R44

SERVICE BULLETIN SB-6

SUBJECT: Placard to Prohibit Pushovers

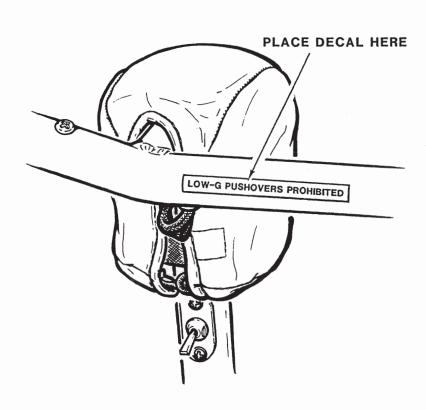
BACKGROUND: It has been determined that the risk involved in demonstrating low-G maneuvers in the air is too great. To insure that no intentional low-G pushover maneuvers will be performed, a placard is to be placed on the cyclic stick prohibiting such maneuvers.

Clean area of cyclic control and install A654-83 decal in clear view of pilot as shown below (decal enclosed with service bulletin to aircraft owners).
